City of Boise ADA  
Assessment

# Appendix A-Boise Depot

Report #TO21-B020

**Location:** Back Stairwell  
**Schedule:** 2022  
**Estimated Cost:** \$1,000.00

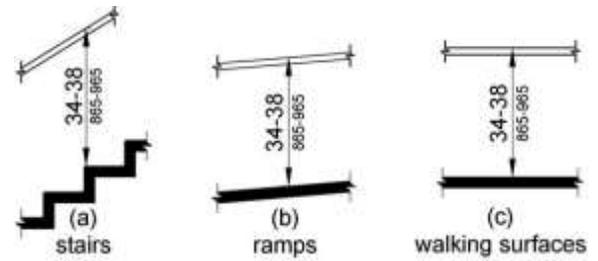
**2010 ADA Standards for Accessible Design Codes §505.4**  
Handrails are not located at a compliant height at 33" above the stair nosings.

Raise the handrails to a minimum height of 34" and a maximum of 38" above the stair nosings. Ensure that the handrails are at a consistent height along the stair treads.

**Location:** Brides Room  
**Schedule:** 2021  
**Estimated Cost:** \$100.00

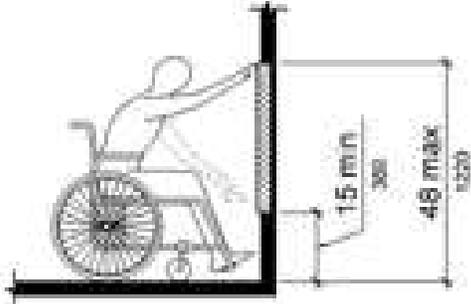
**2010 ADA Standards for Accessible Design Codes §308.2.1**  
The hooks are outside of the unobstructed forward reach range at 48.5" and 78" above the floor.

Lower the hooks by 0.5" to meet the accessible reach range of 48" maximum above the floor.

**Location:** Elevator Foyer  
**Schedule:** 2021  
**Estimated Cost:** \$100.00

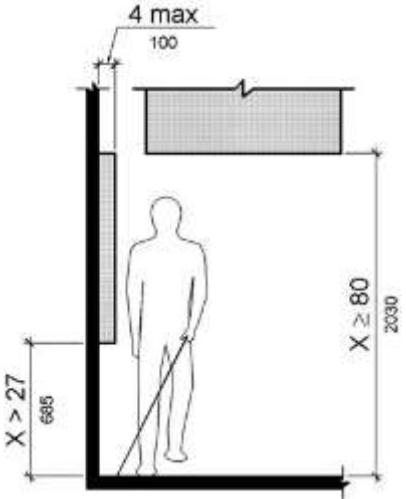
**2010 ADA Standards for Accessible Design Codes §307.2**  
The AED protrudes 6" into the circulation space at 43.25" above the floor.

Recess the AED so it protrudes a maximum of 4", lower it so the bottom edge is 27" maximum above the floor, or place a cane detectable object beneath it.

**Location:** Entire Facility  
**Schedule:** 2021  
**Estimated Cost:** \$4,700.00

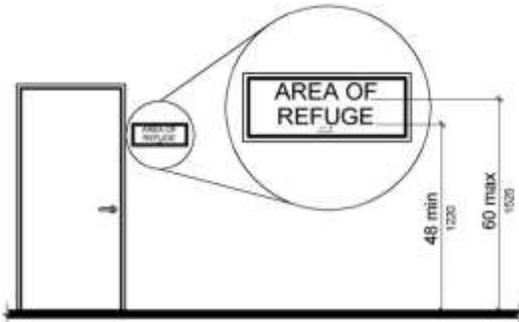
**2010 ADA Standards for Accessible Design Codes** §216.2, §703  
There are no tactile signs identifying 47 permanent rooms.

Install tactile signage on the latch side of the doorway at a height of 48" minimum to 60" maximum above the floor, identifying room by name or room number.  
Signs shall be Braille with raised lettering and should be placed on the wall in the center of an 18"x18" clear floor space.

**Location:** Great Hall Main Entrance  
**Schedule:** 2021  
**Estimated Cost:** \$500.00

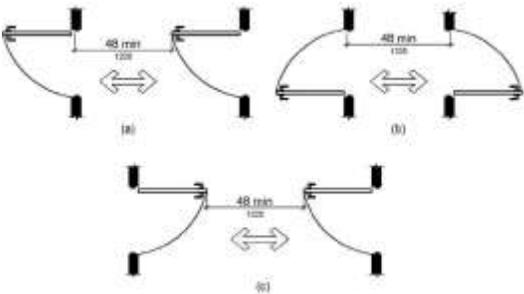
**2010 ADA Standards for Accessible Design Codes §404.2.6**  
Between the two hinged doors, the length is 42.75".

Reverse the swing of one of the doors to ensure that the distance between the two doors when open is a minimum of 48".

**Location:** Great Hall Men's Restroom  
**Schedule:** 2021  
**Estimated Cost:** \$100.00

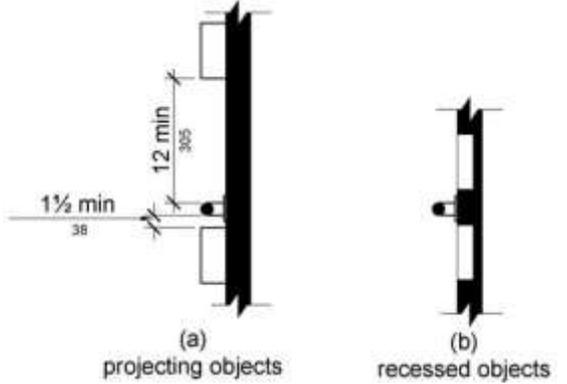
**2010 ADA Standards for Accessible Design Codes** §308.2.1, §609.3  
The space between the grab bar and the toilet seat covers is 6.25".  
The toilet seat covers are outside of the unobstructed forward reach range at 49" above the floor.

Relocate the toilet seat covers to a location that is at least a distance of 12" or greater above the grab bar.  
Lower the toilet seat covers by 1" to meet the accessible reach range of 15" minimum and 48" maximum above the floor.

**Location:** Great Hall Men's Restroom

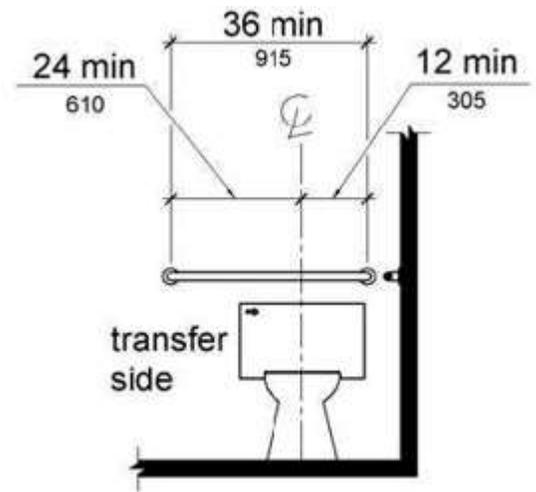
The rear grab bar is located 11.5" to the center of the toilet.

Remount the rear grab bar 12" from the centerline of the water closet minimum on one side and 24" minimum on the other.

**Location:** Great Hall Men's Restroom  
**Schedule:** 2021  
**Estimated Cost:** \$500.00

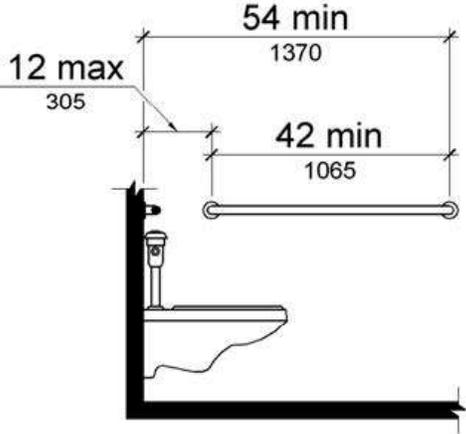
**2010 ADA Standards for Accessible Design Codes §604.5.1**  
The side grab bar is located 6" from the rear wall.

Remount the side grab bar 12" maximum from the rear wall and extending 54" minimum from the rear wall.

**Location:** Great Hall Men's Restroom  
**Schedule:** 2022  
**Estimated Cost:** \$1,000.00

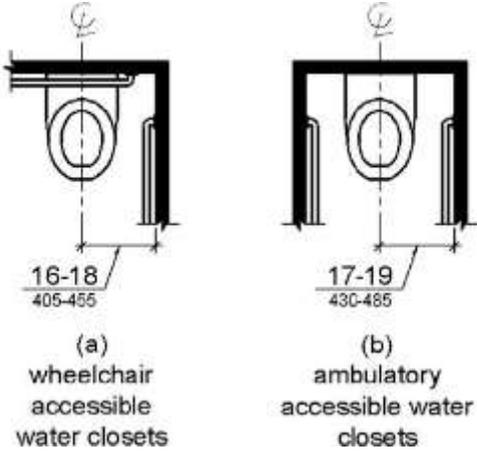
**2010 ADA Standards for Accessible Design Codes §604.2**  
The centerline of the toilet is located 20" from the sidewall.

Reposition the centerline of the toilet to be within 16" minimum and 18" maximum from the sidewall.

**Location:** Great Hall Men's Restroom  
**Schedule:** 2022  
**Estimated Cost:** \$1,000.00

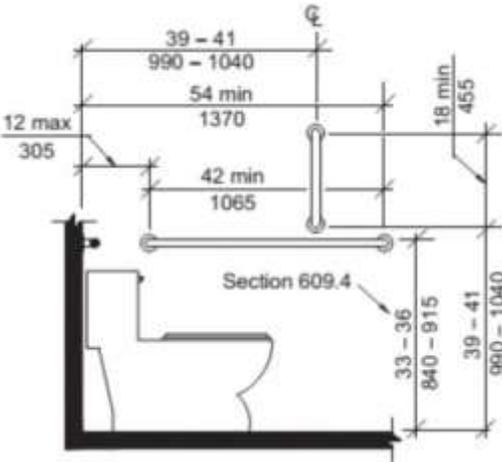
**2010 ADA Standards for Accessible Design Codes** ICC A117.1 §604.5.1  
The accessible water closet does not have a vertical grab bar.

Install an 18" long (minimum) vertical grab bar on the side wall. The grab bar shall be mounted with the bottom located at 39" minimum and 41" maximum above the floor. The centerline of the vertical grab bar shall be located 39" minimum and 41" maximum from the real wall.

**Location:** Great Hall Railroad Exit  
**Schedule:** 2021  
**Estimated Cost:** \$500.00

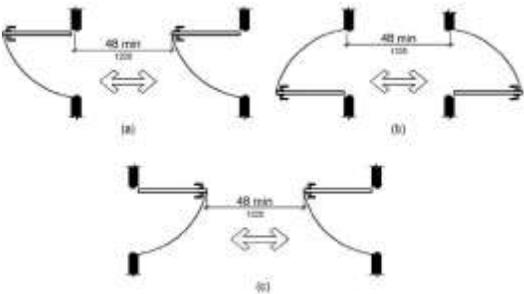
**2010 ADA Standards for Accessible Design Codes §404.2.6**  
Between the two hinged doors, the length is 46".

Reverse the swing of one of the doors to ensure that the distance between the two doors when open is a minimum of 48".

**Location:** Great Hall Women's Restroom  
**Schedule:** 2021  
**Estimated Cost:** \$100.00

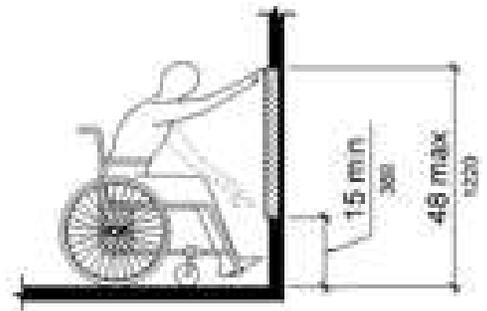
**2010 ADA Standards for Accessible Design Codes §308.2.1**  
The hook is outside of the unobstructed forward reach range at 51.5" above the floor.

Lower the hook by 3.5" to meet the accessible reach range of 48" maximum above the floor.

**Location:** Great Hall Women's Restroom

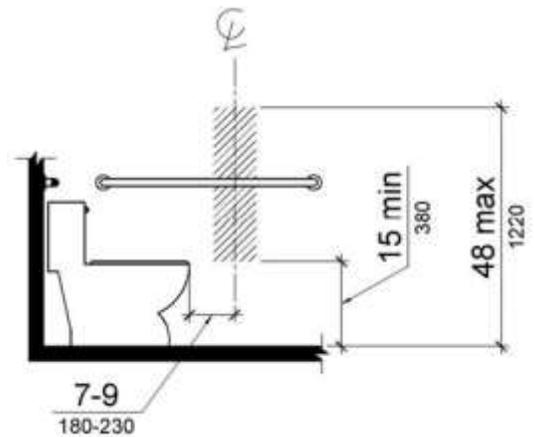
The toilet paper dispenser is located out of the accessible reach range.

Remount the toilet paper dispenser to 7" minimum and 9" maximum in front of the water closet measured to the centerline of the dispenser.

The outlet of the dispenser shall be 15" minimum and 48" maximum above the floor and shall not be located behind.

**Location:** Great Hall Women's Restroom  
**Schedule:** 2021  
**Estimated Cost:** \$100.00

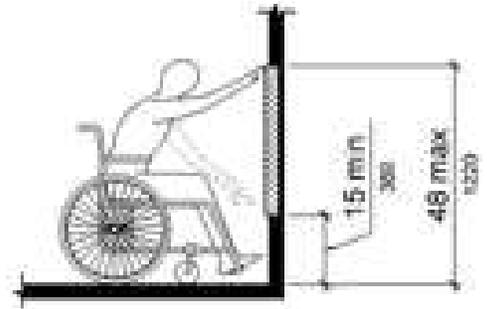
**2010 ADA Standards for Accessible Design Codes** §609.3, §308.2.1  
The toilet seat covers are outside of the unobstructed forward reach range at 49.5" above the floor. The space between the grab bar and the toilet seat covers is 6.25".

Lower the toilet seat covers by 1.5" to meet the accessible reach range of 48" maximum above the floor.  
Relocate the toilet seat covers to a location that is at least a distance of 12" or greater above the grab bar.

**Location:** Great Hall Women's Restroom

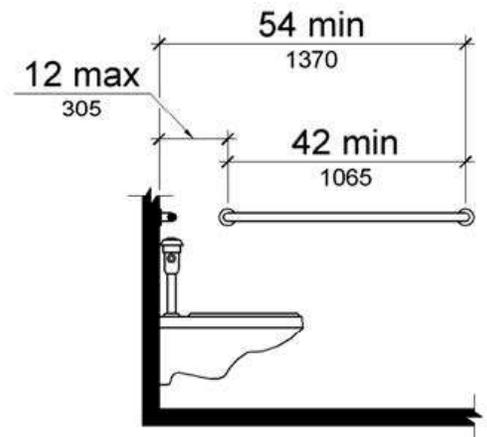
The side grab bar is located 6" from the rear wall.

Remount the side grab bar 12" maximum from the rear wall and extending 54" minimum from the rear wall.

**Location:** Great Hall Women's Restroom  
**Schedule:** 2022  
**Estimated Cost:** \$1,000.00

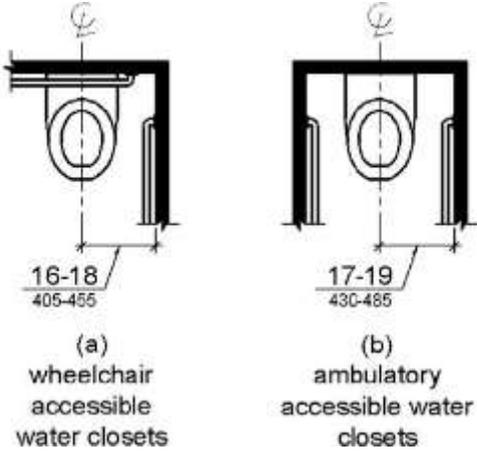
**2010 ADA Standards for Accessible Design Codes §604.2**  
The centerline of the toilet is located 18.5" from the sidewall.

Reposition the centerline of the toilet to be within 16" minimum and 18" maximum from the sidewall.

**Location:** International Festival and Events Association

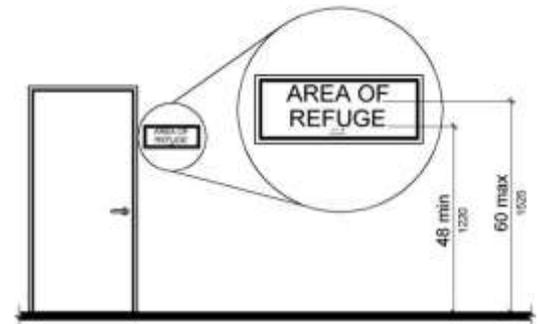
There is no tactile sign identifying the permanent rooms.

Install tactile signage on the latch side of the doorway at a height of 48" minimum to 60" maximum above the floor, identifying room by name or room number.

Signs shall be Braille with raised lettering and should be placed on the wall in the center of an 18"x18" clear floor space.

**Location:** International Festival and Events Association Kitchen  
**Schedule:** 2021  
**Estimated Cost:** \$100.00

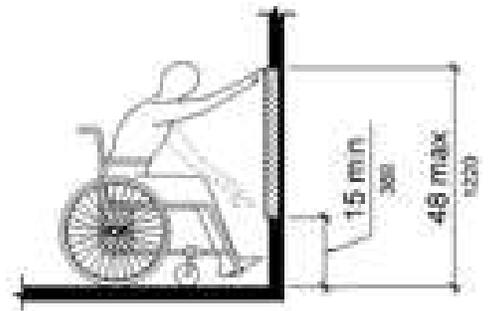
**2010 ADA Standards for Accessible Design Codes §308.2.1**  
The paper towel dispenser is outside of the unobstructed forward reach range at 52" above the floor.

Lower the paper towel dispenser by 4" to meet the accessible reach range of 48" maximum above the floor.

**Location:** International Festival and Events Association Men's Restroom

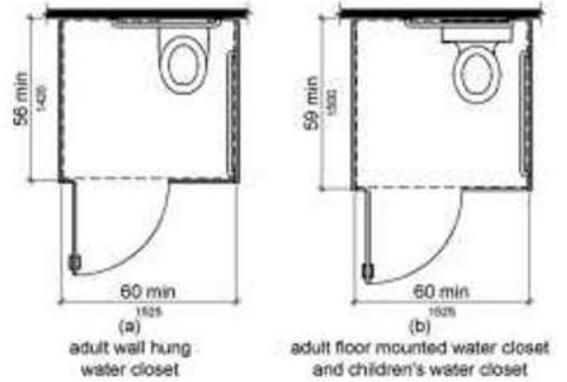
The toilet compartments are too small at 33.5" wide and 58" deep.

Combine the two non-accessible stalls into one 60" wide wheelchair accessible toilet stall, complying with §604.8.

**Location:** International Festival and Events Association Women's Restroom

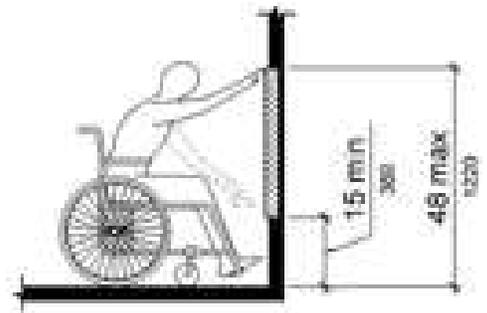
The dispenser is outside of the unobstructed forward reach range at 51" above the floor.

Lower the dispenser by 3" to meet the accessible reach range of 48" maximum above the floor.

**Location:** International Festival and Events Association Women's Restroom

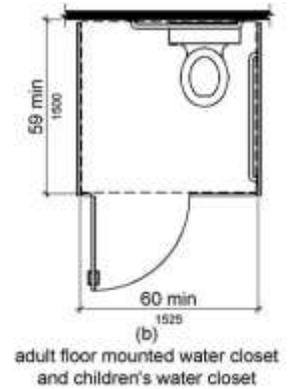
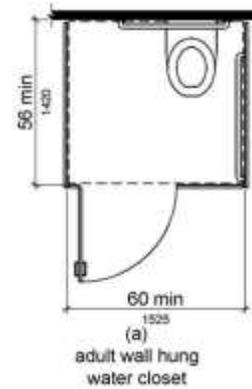
The toilet compartments are too small at 33" wide and 58" deep.

Combine the two non-accessible stalls into one 60" wide wheelchair accessible toilet stall, complying with §604.8.

**Location:** Meeting Station

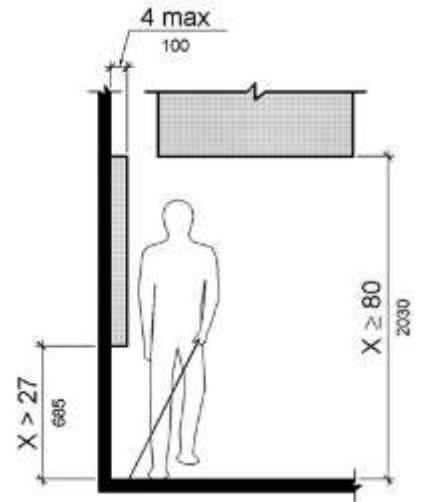
The counter protrudes 20.5" into the circulation space at 32.5" above the floor.

Extend the sides of the counter down so the bottom edge is 27" maximum above the floor to provide cane detectability.

**Location:** Meeting Station Men's Restroom

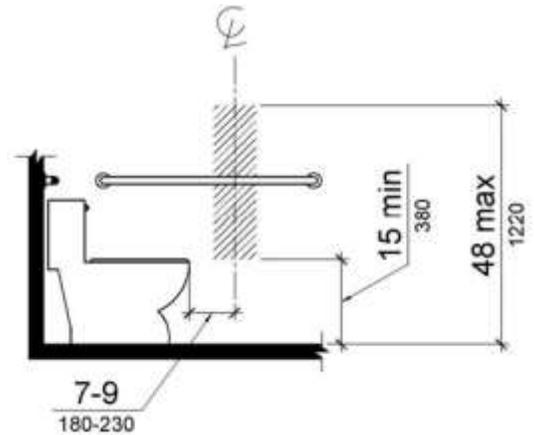
The toilet paper dispenser is located out of the accessible reach range.

Remount the toilet paper dispenser to 7" minimum and 9" maximum in front of the water closet measured to the centerline of the dispenser.

The outlet of the dispenser shall be 15" minimum and 48" maximum above the floor and shall not be located

**Location:** Meeting Station Men's Restroom

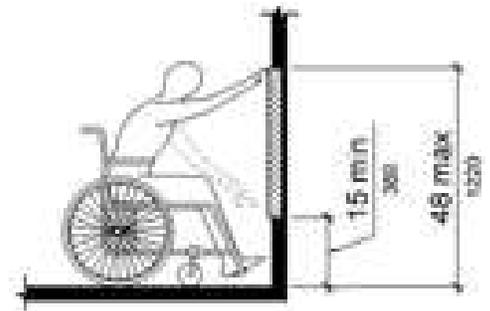
The hook is outside of the unobstructed forward reach range at 60" above the floor.

Lower the hook by 12" to meet the accessible reach range of 48" maximum above the floor.

**Location:** Meeting Station Men's Restroom

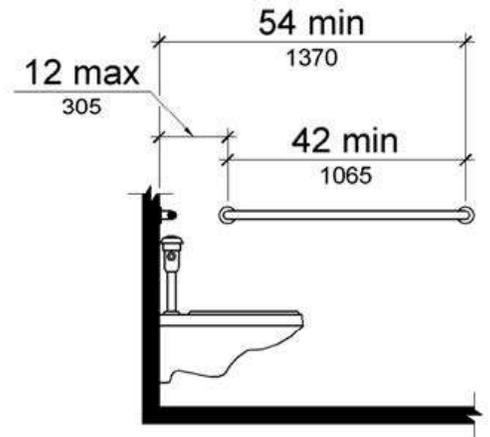
The side grab bar is located 4" from the rear wall and is 37" long.

Replace the side grab bar with one that is a minimum of 42" long minimum, located 12" maximum from the rear wall and extending 54" minimum from the rear wall.

**Location:** Meeting Station Men's Restroom

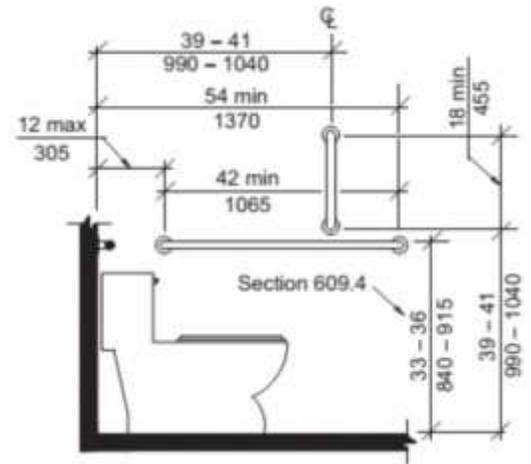
The accessible water closet does not have a vertical grab bar.

Install an 18" long (minimum) vertical grab bar on the side wall. The grab bar shall be mounted with the bottom located at 39" minimum and 41" maximum above the floor.

The centerline of the vertical grab bar shall be located 39" minimum and 41" maximum from the rear wall.

**Location:** Meeting Station Men's Restroom

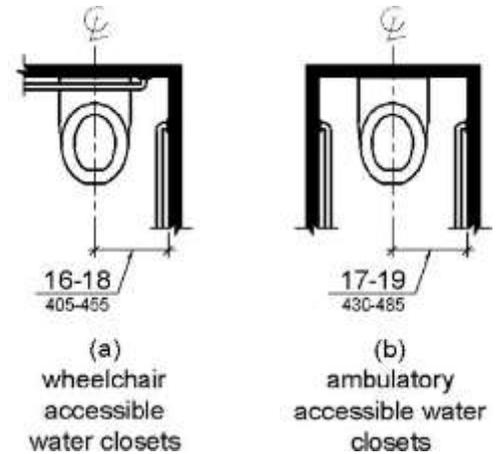
The toilet is 20" above the floor.

The toilet is located 20.5" from the sidewall.

Reposition the toilet to be within 16" minimum and 18" maximum from the sidewall.
